Horn Lifting Fixture Modification
Engineering Note # 138 from 1/16/03

Stress Analysis of Horn Lifting Fixture

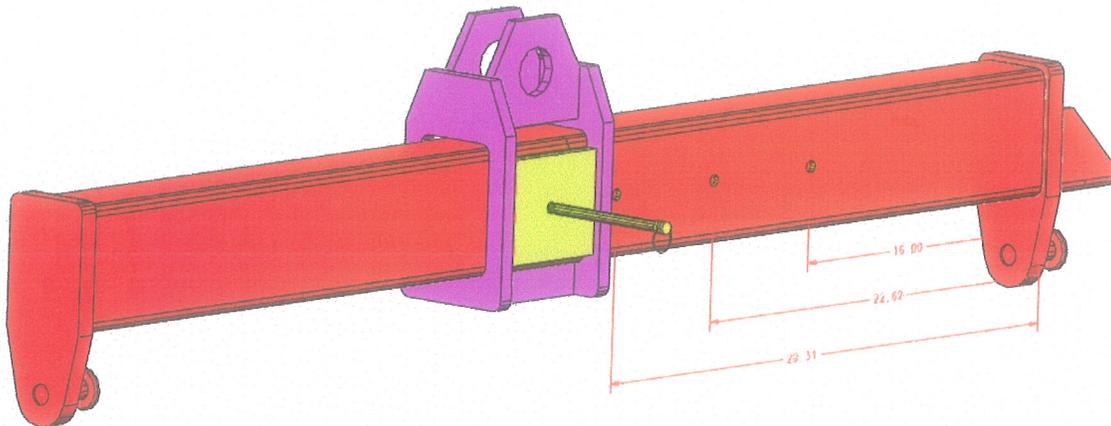
1. A request has been made by Dave Pushka PPD (Mechanical Engineering) to add fixed locating positions to this lifting fixture for the remote lifting of Horns #1, #2 and Target Carrier and that I should contact Hiep Le (Accelerator Division) for these locations.

2. I contacted Hiep Le for this information and he referred me to visiting MI-8, viewing the fixture and measuring the markings on this fixture which I have done. These dimensions as shown on the Solid Model below from the inside of the downstream end plate are 16", 22 5/8" and 29 5/16".

5. I have since pulled 2D construction drawings from which I made a Solid Model of existing fixture (shown below), lifting tube assembly in red and pick point slider in magenta, I then added pin locating plates in yellow to both sides of slider weldment and a positioning pin with detent also in yellow. As the slider is captured by the tube endplates and for simplicity of aligning pinning holes, slider block should be positioned in each of the pre measured locations and line bore through these plates as well as the lifting tube after welding.

6. As the locating pins penetrate the lifting tube on the neutral axis, no additional calculations are needed for this engineering note authored by Bob Wands from 1/16/03. This statement will be inserted into original Engineering Note #138 to document changes made and to illustrate that the modifications have been given consideration in this engineering note. E. LaVallie 3/17/05.
